SERVICE BULLETIN

#16 REV.A New Clamp Pressure Switch 4/24/15

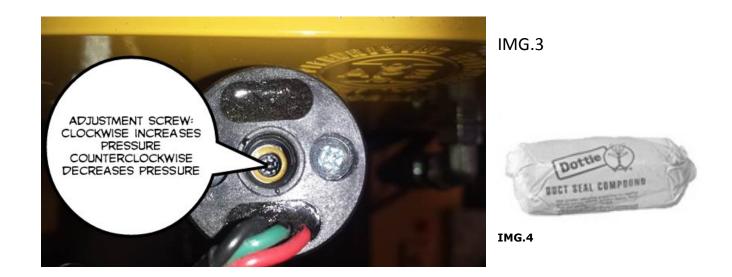
They will be set in the same method as the other switch was. (See Service Bulletin #12) The switch will need to be installed upside down to prevent moisture getting inside it. (See IMG.1) To adjust this switch remove the cover screw with a 5/32" allen wrench. (See IMG. 2). Then use a 1/8" allen wrench to adjust to proper setting. (See IMG.3) When the adjustment is completed reinstall cover screw. We also suggest putting a dollop of Dottie Seal Compound on the cover screw when finished. Dottie can be purchased at any electrical supplier. (See IMG. 4)
